Addendum #1

Pleasure Ridge Park

Issue Date: May 5, 2021

PLEASURE RIDGE PARK
FIRE STATION 1

01 MECHANICAL PIPING FLOOR PLAN
SCALE: 1/8" = 1'-0"

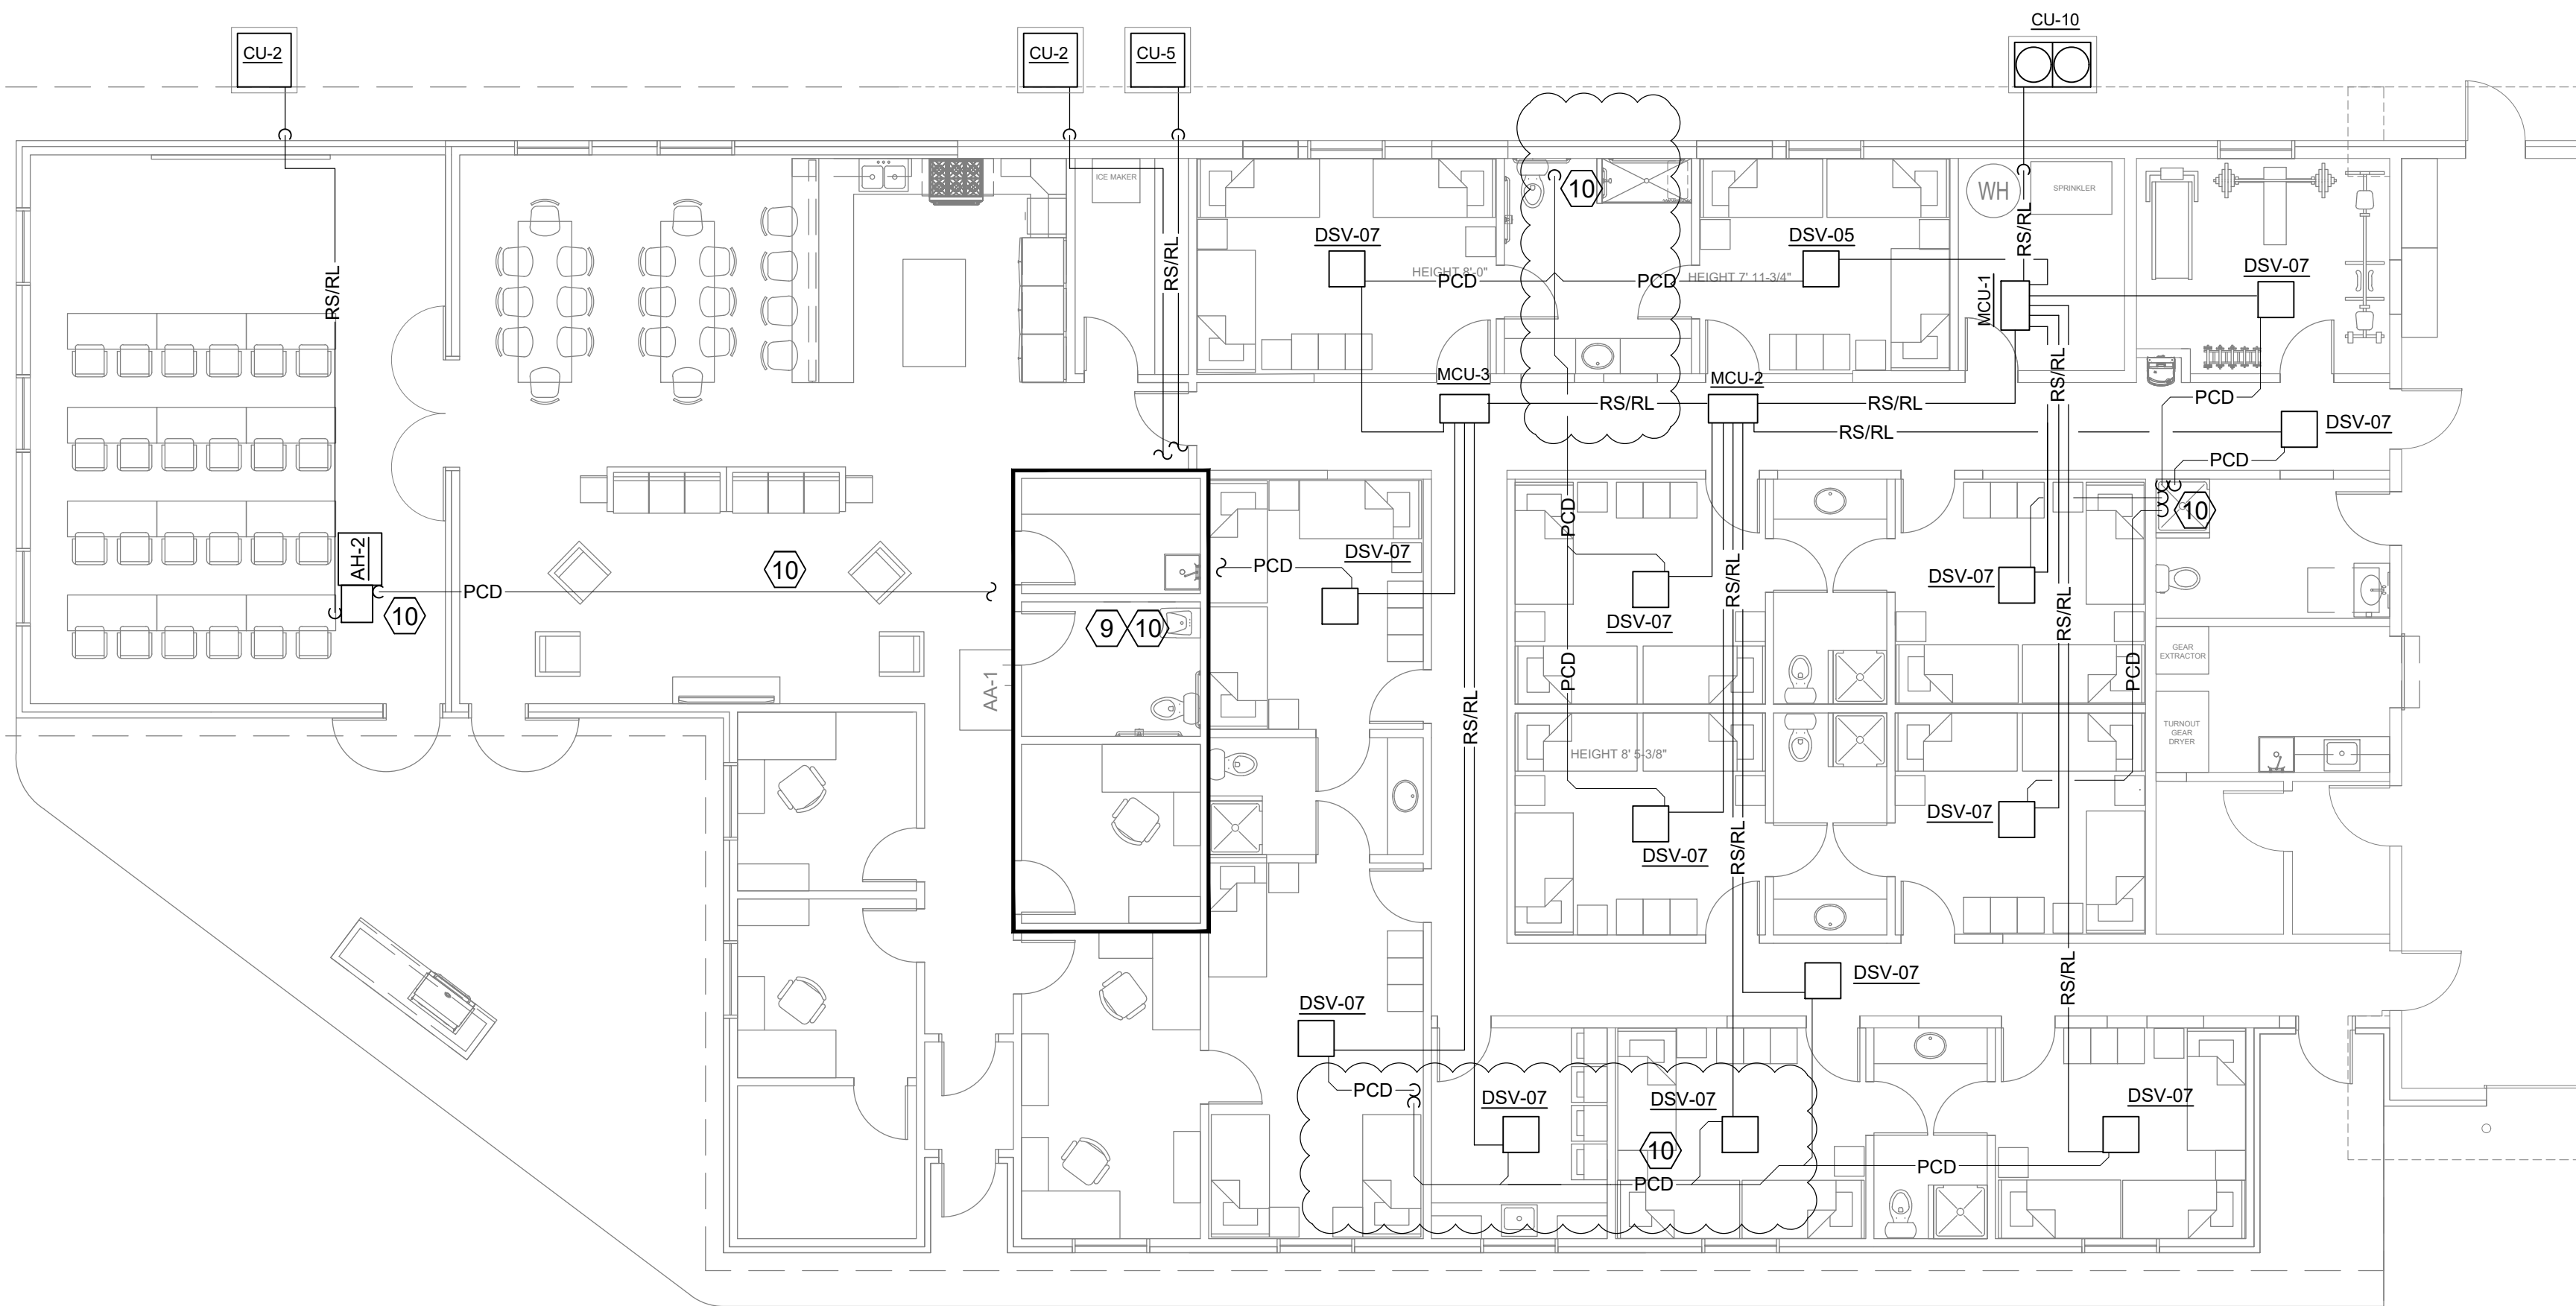
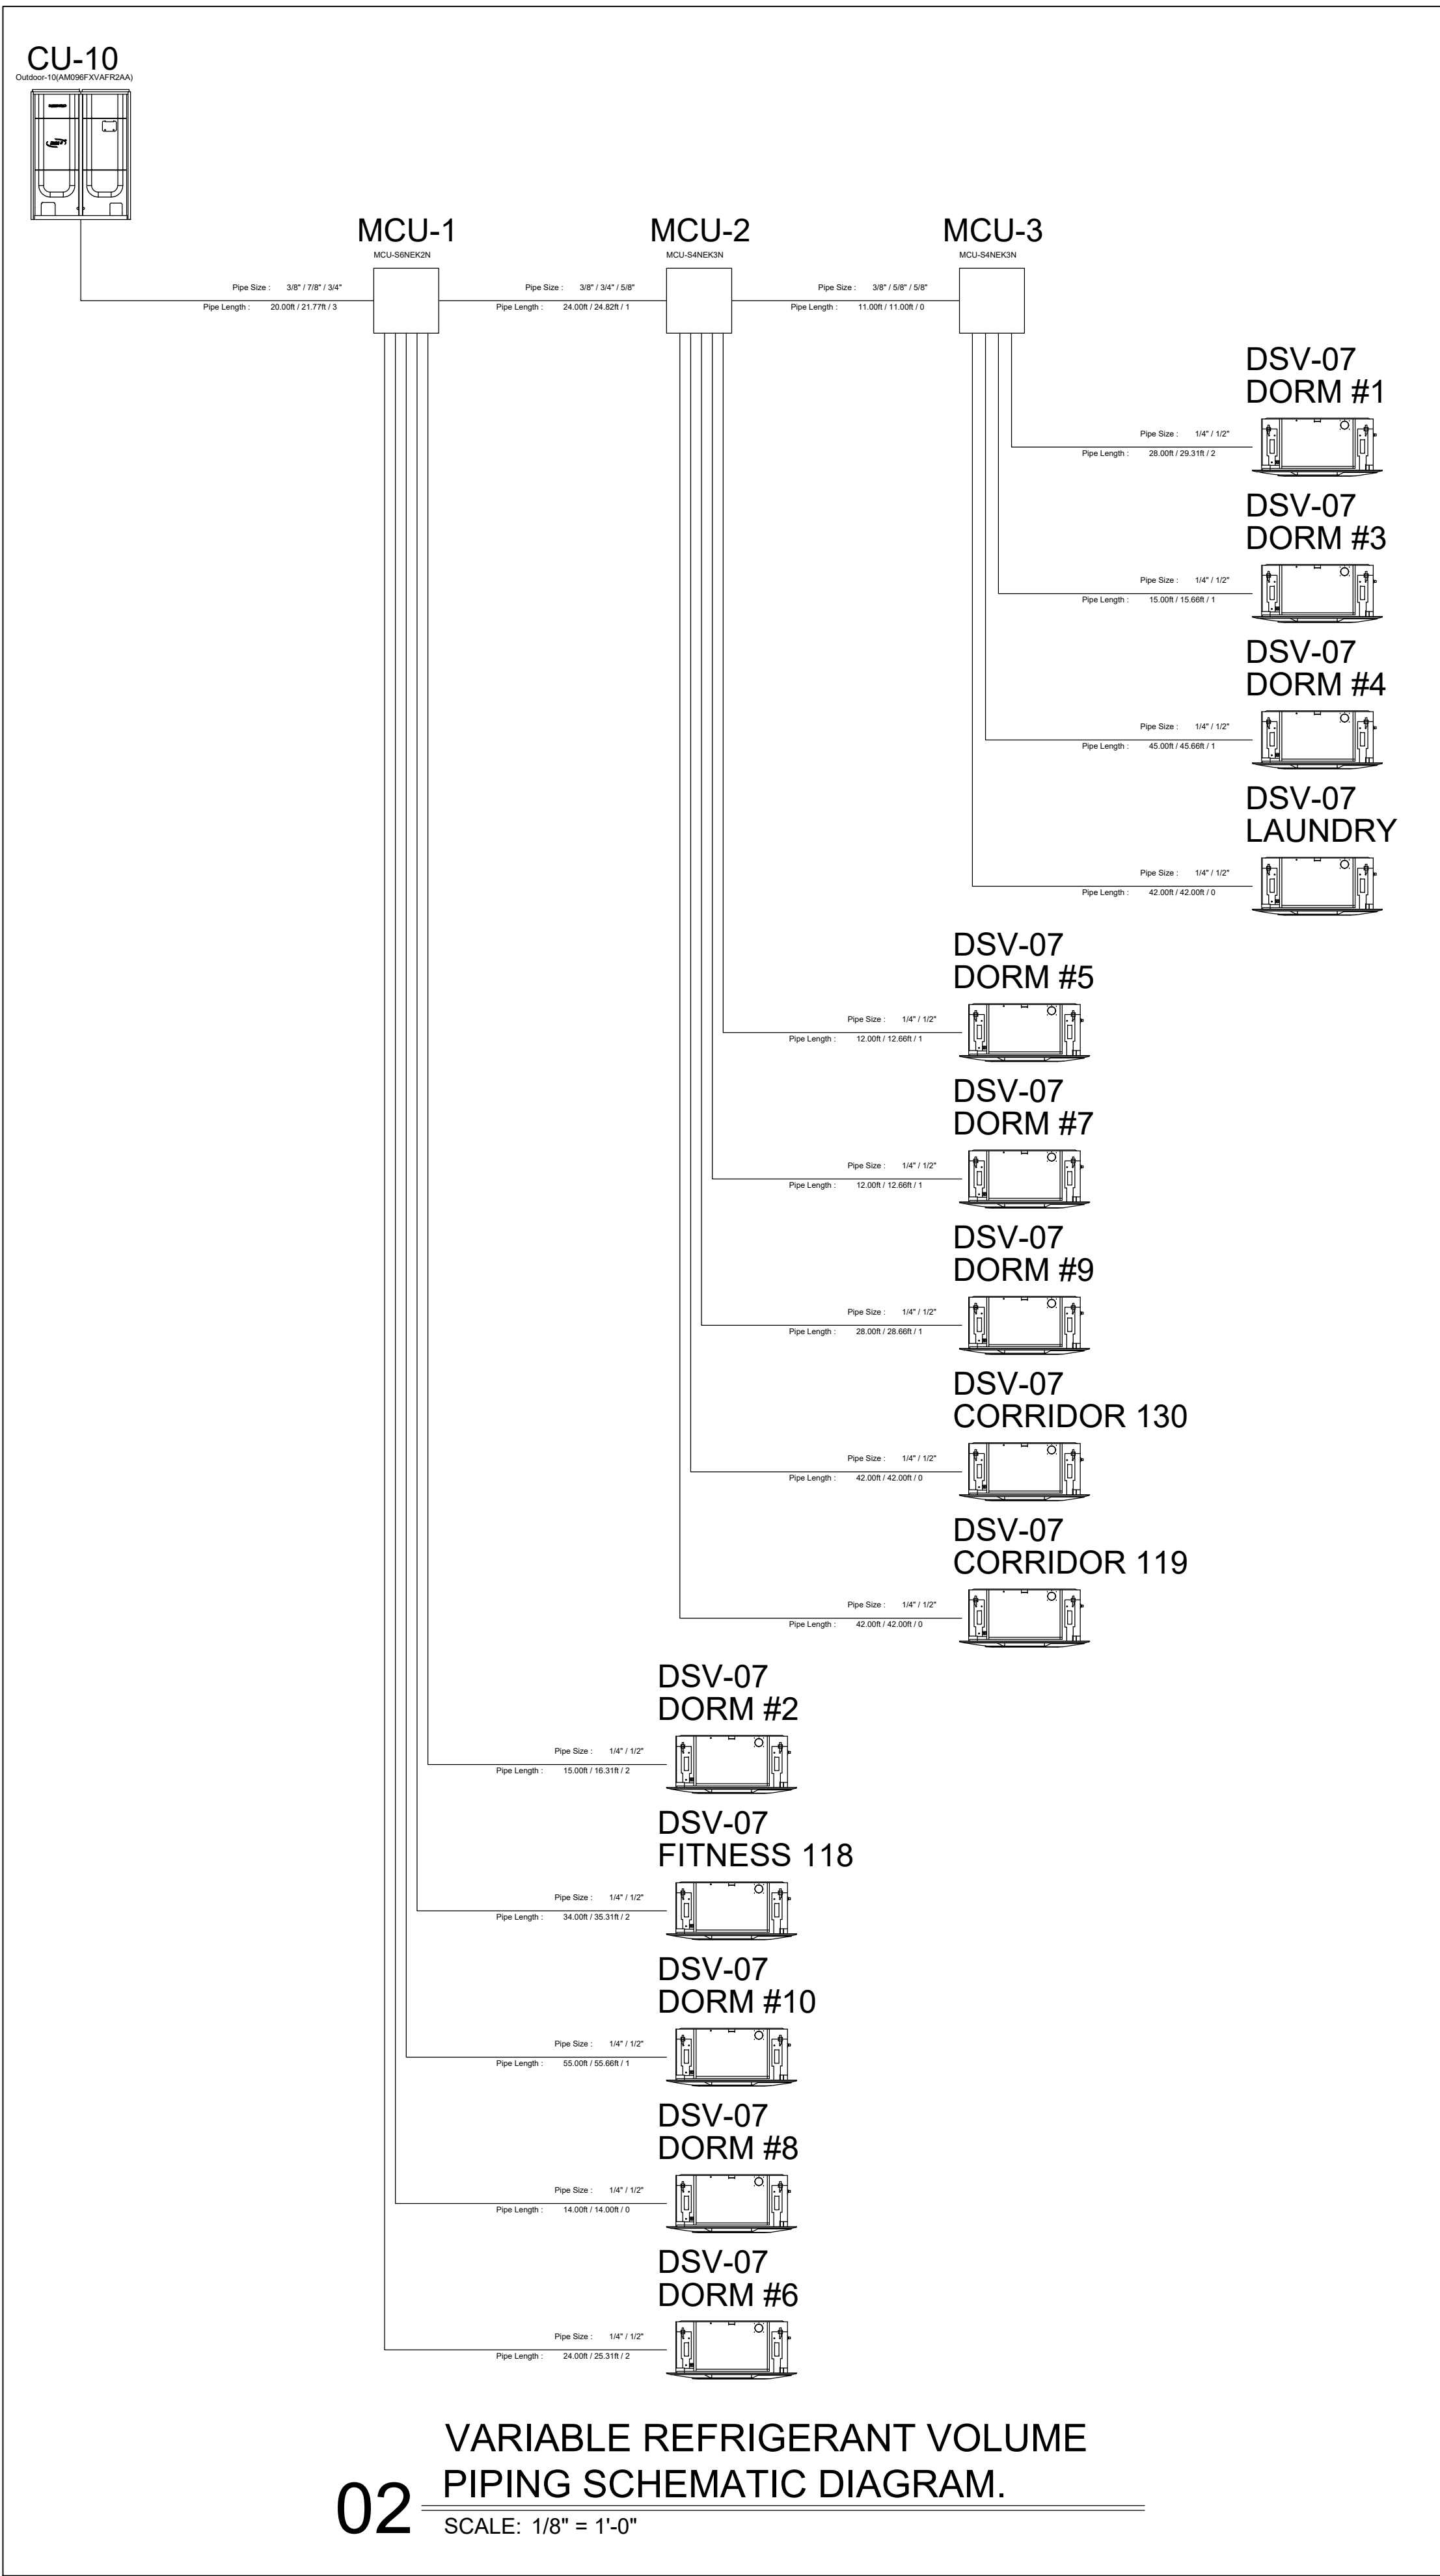
7. Reference attached drawing **M1.02R1** for revised ceiling callouts.
8. See revised sheet **M1.03R1** for revised condensate piping routes for VR System.

9. **M1.03R1** Note #3 for VRF DSV Schedule shall read “Provide with plaster frame for installation in GYP or Plaster ceiling coordinate where required with architectural ceiling plans. Provide access door in gypsum ceilings.”

- REMARKS:
1. PROVIDE FACTORY ENGINEERED REFRIGERANT PIPING SYSTEM WITH FACTORY FITTINGS AND BRANCH SELECTOR BOXES.
 2. PROVIDE WITH UL LISTING.
 3. PROVIDE WITH PLASTER FRAME FOR INSTALLATION IN GYP OR PLASTER CEILING. COORDINATE WHERE REQUIRED WITH ARCHITECTURAL CEILING PLANS. PROVIDE ACCESS DOOR IN GYPSUM CEILINGS.
 4. PROVIDE FACTORY START UP FOR EQUIPMENT.
 5. INSTALLING CONTRACTOR MUST HAVE COMPLETED MANUFACTURER'S CERTIFIED INSTALLATION CLASS WITHIN THE PAST 36 MONTHS.
 6. PROVIDE WITH INTEGRAL CONDENSATE PUMP AND DRAIN OVERFLOW SAFETY INTERLOCK SWITCH.
 7. PROVIDE WALL MOUNTED THERMOSTAT AND SENSOR.
 4. ACCEPTABLE MANUFACTURERS: SAMSUNG, DIAKIN LG, MITSUBISHI.
